Exhibit O

Re: Structural Concerns in your detached garage

Plat for Building Permit of SQUARE 987 LOT 8

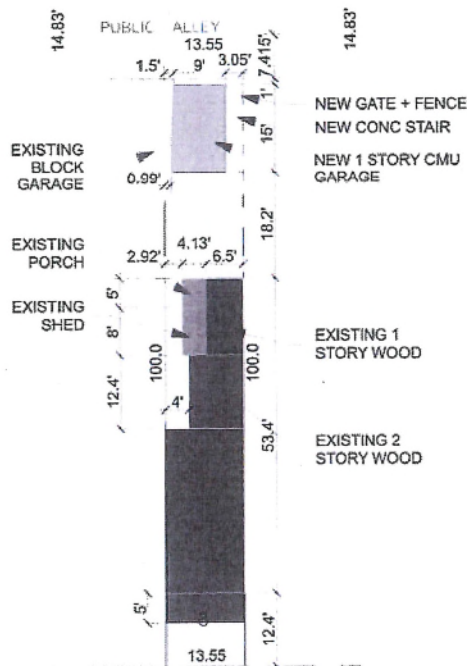
- d. The color of the roof rafters indicate that the framing has been in place for more than 20 years.
 - e. We have reviewed the plans for the new garage at 1120 Park St. The plans call for the new garage to abut your garage. The plans also show that your garage extends into the property at 1120. This is evidenced by the site plan that shows the new garage being offset by 0.99' at the SW corner and 1.5' at the NW corner from the property line between 1118 and 1120.

- f. The plans provided to us for the garage at 1120 does not show a continuous wall between the garages at 1118 and 1120.

The plans for the new garage at 1120 Park Street clearly show your garage on their property. The plans also allow for your garage to remain.

Given the cracking and movement in the East wall of your garage we do not recommend that the construction at 1120 Park Street use the wall for structural support. Before using an existing foundation and wall for structural support, DCRA will normally require proof in the form of test pit pictures and calculations that the existing structure can safely support the existing and proposed structures. If the foundation cannot, it is the responsibility of your neighbor to either provide new foundations for their structure or underpin the existing structure so that it can support both garages.

We recommend that the garage structure for 1120 Park Street be revised so that it does not apply loads to East wall of your garage as is required by DCRA. Alternately your neighbor could underpin the existing East wall so that it can safely support both structures. In reviewing the plans for the structure next door, it is our opinion that adding the additional structure will not be very complicated. We also recommend that the plans for the garage at 1120 include an expansion joint between the two structures that will allow them to move independently. Any flashing placed between the two structures should be installed to allow for 1 ½ to 2" of movement without breaking the water seal.
